Contract #: 04-0120F4Cty: SF/ALA Rte: 80 PM: 13.2/13.9File #: 69.25B**QUALITY ASSURANCE -- NON-CONFORMANCE REPORT****Location:** Changxing Island, Shanghai, China**Report No:** NCR-000781**Prime Contractor:** American Bridge/Fluor Enterprises, a JV**Date:** 30-Jun-2010**Submitting Contractor:** Zhenhua Port Machinery Company, Ltd (ZPMC), Changxing Island**NCR #:** ZPMC-0743**Type of problem:****Welding****Concrete****Other****Welding****Curing****Procedural****Bridge No:** 34-0006**Joint fit-up****Coating****Other****Component:** SEG11AE, PP97 LD2A flange to FB10A**Procedural****Procedural****Description:****Reference Description:** Missed UT Indication**Description of Non-Conformance:**

Report No: NCR-000781

NCR #: ZPMC-0743

Component: SEG11AE, PP97 LD2A flange to FB10A

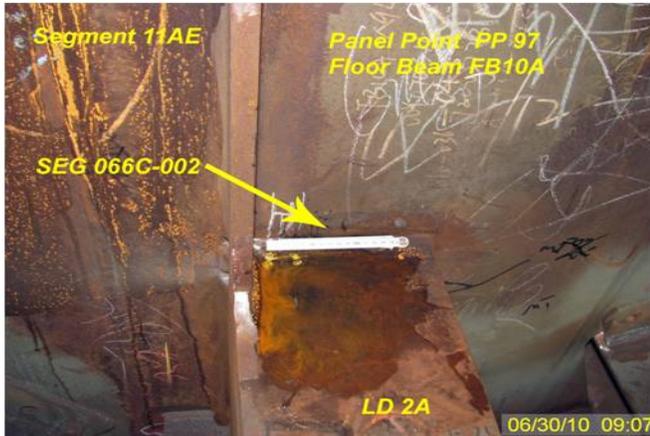
During the Quality Assurance Ultrasonic Testing (UT) verification of welds located on Segment 11AE, QA discovered the following issue:

- One (1) Class "A" rejectable indication measuring approximately 30 mm in length.
- The weld is a Complete Joint Penetration (CJP) 'T' joint single bevel groove weld joining the Longitudinal Diaphragm (LD2A) Flange, to the Floor beam FB10A Web, on the West side of Panel Point 97.
- The indication db rating was (+3).
- The thickness of the LD flange plate is 25 mm.
- Depth of the indication is 21 mm.
- The "Y" location is approximately 10mm measured from end of the flange.
- The weld is identified as SEG066C-002.
- The indication is clearly marked near the weld.
- Segment 11AE is located in the segment repair yard south of the fabrication bay 14.
- This weld joint is designated as Non Seismic Performance Critical Weld Member (Non-SPCM).

The Notice of Witness Inspection Number (NWIT) is 006079. The indication is located within the area that has been previously tested and accepted by ZPMC Quality Control (QC) personnel.

Reference Resolution: ZPMC has repaired the missed indication and is providing the weld repair report and NDT performed after the repair to show it is acceptable.

ZPMC has repaired the missed indication and is providing the weld repair report and NDT performed after the repair to show it is acceptable. ZPMC QA has discussed this issue with their NDT Department head to reduce missed indications in UT by ensuring inspectors are not over tasked to perform inspections too quickly. Based on this ZPMC requests closure of this NCR.

The proposed resolution is acceptable. This NCR is considered closed.

WELD NUMBER: SEG066C-002

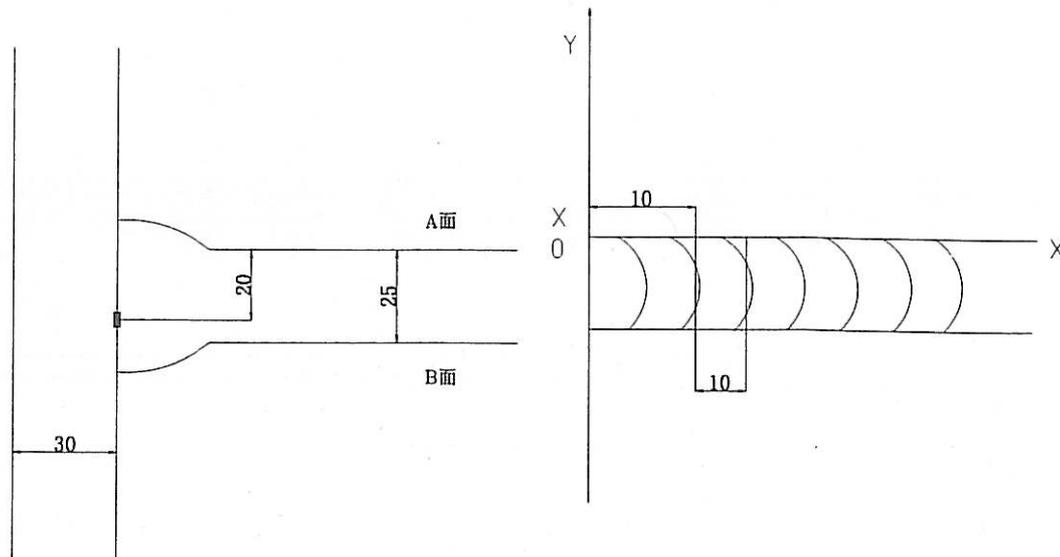
焊缝缺陷描述: (普通UT探伤发现的缺陷长度小于最大允许长度)

(Description of welding discontinuity): Rejected indication found by ultrasonic inspection is less than the maximum allowance aggregate length.

产生原因:

Caused:

1. 焊道未及时处理干净。

1. Did not clear the weld pass completely in time.

1. Gouge or grind from nearer side from metal edge ($D \leq 0.65T$, "D" is depth of defects, "T" is thickness of metal) to remove all defects;

2. Follow repair WPS for joint preparation, preheat, and weld deposit;

3. Grind the repaired area flush with base metal or the adjacent weld;

4. Check the welds according to the working drawings.

1. Improve monitoring of welding and interpass cleaning.
